Administrator KC Becker
US EPA, Region 8
1595 Wynkoop Street
Denver, CO 80202-1129
Via Email: Becker.KC@epa.gov

November 7, 2023

I. CDPHE Failure to Complete Recommended Permit Reviews

IV. Permit Issues

CC&V Modeling Results

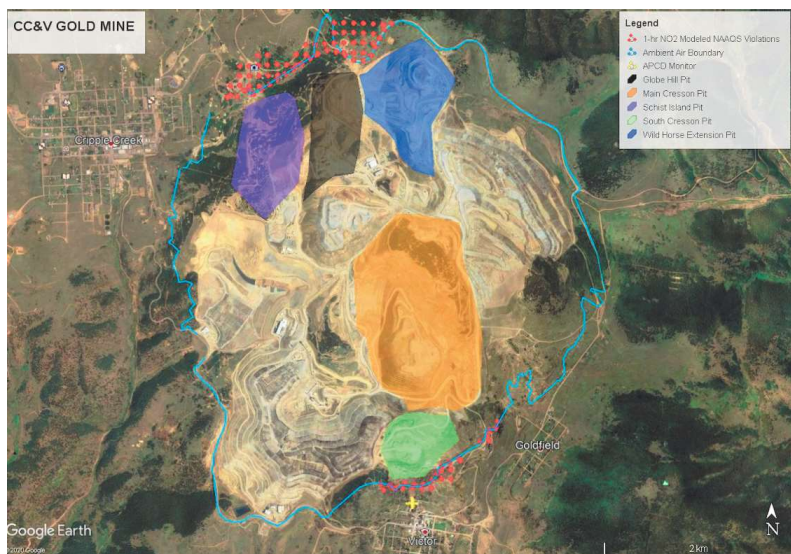
You requested the maximum modeled concentrations on both the south and north portion of the CC&V Mine property boundary shown in the figure below and listed as 1-hr NO₂ Modeled NAAQS violations.

As you know, officially there aren't any modeled violations at the CC&V Mine. That's because of the 01/14/19 and 01/28/19 emails from Gordon Pierce requesting to remove the concentration exceeding the NAAQS from the report and to replace them with a value that was lower and that was based on incorrect data. Therefore officially the highest modeled concentration is of 187.7 ug/m³ (99.77 ppb). The NAAQS is of 100 ppb.

Reality however, is very different. The actual highest modeled design concentration in the southern area of the mine is of 229.34 ug/m³ (121 ppb). In the northern area of the mine this concentration is of 225.78 ug/m³ (120 ppb). This is the information you are now requesting.

Those results above beg the question, if the Division is now acknowledging the modeled NAAQS violations, why would the permit be issued?
